APPLICATION NO.	FILING DATE	FIRST NAMED INVENTOR	ATTORNEY DOCKET NO.	CONFIRMATION NO.
10/560,074	06/23/2006	Thomas Scherb	P28845	9642
7055 7590 12/08/2009 GREENBLUM & BERNSTEIN, P.L.C. 1950 ROLAND CLARKE PLACE RESTON, VA 20191				
EXAMINER				
FORTUNA, JOSE A				
ART UNIT		PAPER NUMBER		
1791				
NOTIFICATION DATE		DELIVERY MODE		
12/08/2009		ELECTRONIC

Office Action Summary

DETAILED ACTION

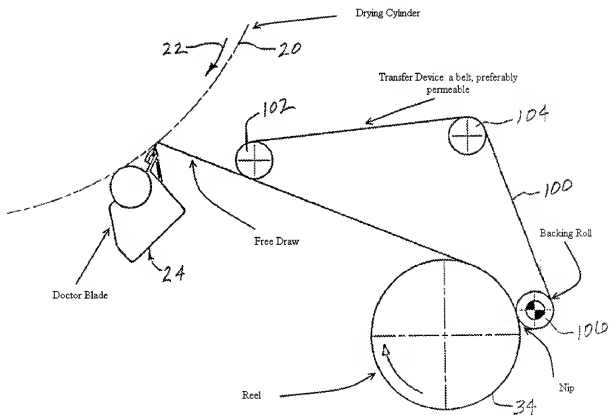
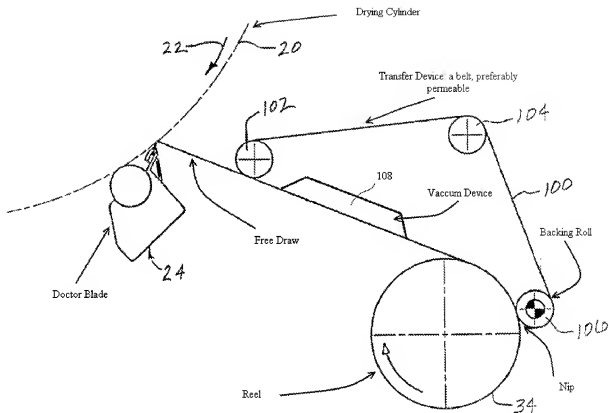
Linden teaches a device for producing a tissue web which includes a drying cylinder that could be a Yankee Dryer, a creping Doctor and winding device to reel-up the web onto a roll and a transfer device that carries the web from almost the entire run from the doctor blade to the winding roll, see figure 7B and ¶-[0053]. The figure shows also that the web is unsupported, creating a free draw from short distance from the doctor to the beginning of the transfer device, and shows that the web is supported on one side of the transfer device. Linden shows also that the device can include a nip, formed by a backing roll and the reel, see for example ¶-[0053]. Figure 7F shows an embodiment in which the web is

formed using a crescent former and through-air-dried (TAD) having hoods. Linden teaches also that the transfer device can be a belt; preferably a permeable belt and that vacuum can be applied to the web through the permeable belt. The device can be a vacuum box or a device that creates under pressure by blowing air via the Coanda effect, ¶-[0053] and Figures 7B and 7C, see below:

Note that Linden shows that the belt moves around a winding drum of the winding device, i.e., moves around the backing roll (106) that form part of the winding device, see figures above, which is/are equivalent to the winding roll 107 of figure 1 of the current application. As to the force at the winding nip, this is functional limitation, which implies that the system is capable and controlled to produce the claimed nip pressure and the system show by the reference, Linden, is inherently capable of producing such pressure at the nip, since it has all the structural limitations of the claim(s). Therefore, the reference anticipates the claims or at least the minor modification(s) to obtain the claimed

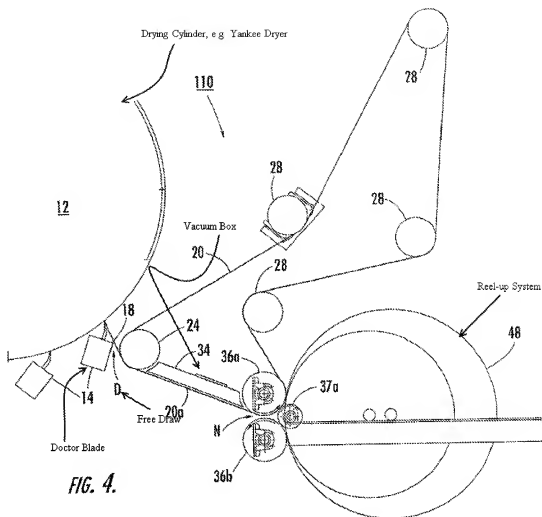
Clarke et al. teach a device for producing a tissue web which includes a drying cylinder, that could be a Yankee Dryer, a creping Doctor and winding device to reel-up the web onto a roll and a transfer device that carries the web from almost the entire run from the doctor blade to the winding roll, see figures, specially figure 4, and ¶-[0036]-[0038]. The figure show also that the web is unsupported, creating a free draw from short distance from the doctor to the beginning of the transfer device, and show that the web is supported on one side of the transfer device. Clarke teach also that the short Draw, (D) can be changed from 4 inches to 48 inches, (0.1 to 1.20 meters), which falls within the claimed range, see ¶-[0024]. Clarke et al. show also that the device can include a nip formed by a backing roll and the reel, figure 4, and ¶-[0036]-[0038]. Clarke et al. teach also that the transfer device can be a belt; preferably a permeable belt and that vacuum can be applied to the web through the permeable belt. The device can be a vacuum box (34) or a device that creates under pressure by blowing air via the Coanda effect, ¶-[0030]-[00333] and Figures 4, below:

Note that Clark et al. show that the belt moves around a winding drum of the winding device, i.e., moves around the backing roll (36a) that form part of the winding device, see figure above, which is/are equivalent to the winding roll 107 of figure 1 of the current application. As to the force at the winding nip, this is functional limitation, which implies that the system is capable and controlled to produce the claimed nip pressure and the system show by the reference, Clark et al., is inherently capable of producing such

FIG. 5

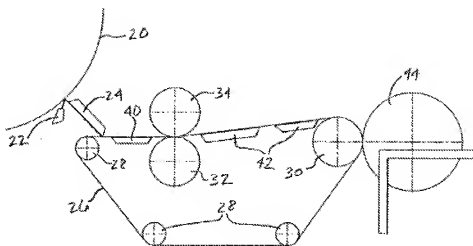
Klerelid et al. teach a device for producing a tissue web which includes a drying cylinder, that could be a Yankee Dryer, a creping Doctor and winding device to reel-up the web onto a roll and a transfer device that carries the web from almost the entire run from the doctor blade to the winding roll, see figures 1-21 and ¶-[0005]-[0014]. The figures show also that the web is unsupported, creating a free draw from short distance from the doctor to the beginning of the transfer device, and shows that the web is supported on one side of the transfer device. Klerelid et al. show that the device can include a nip, formed by a backing roll and the reel, see for example figure 21, and ¶-[0069]. Klerelid et al. teach that the lineal pressure at the winding nip is controlled to be between 100-250 N/m (0.1 kN/m- 0.250 kN/m), ¶-[0071]. Klerelid et al. teach also that the transfer device can be a belt; preferably a permeable belt and that vacuum can be applied to the web through the permeable belt. The device can be a vacuum box or a device that creates under pressure by blowing air via the Coanda effect, ¶-[0040] and Figures 1-21, see figure 5 below:

Note that Klerelid et al. show the belt moves around a winding drum (30) of the winding device, i.e., moves around the backing roll that form part of the winding device, see figures above, which is/are equivalent to the winding roll 107 of figure 1 of the current application. As to the force at the winding nip, even though Klerelid teaches that the pressure at the nip is preferably maintained between 0.1 to .25 kN/m, the system is capable of being controlled to produce the claimed nip pressure, i.e., the system is inherently capable of producing such pressure at the nip, since it has all the structural limitations of the claim(s). Therefore, the reference anticipates the claims or at least the minor modification(s) to obtain the claimed invention, i.e., to apply the claimed nip pressure, would have been obvious to one of ordinary skill in the art.
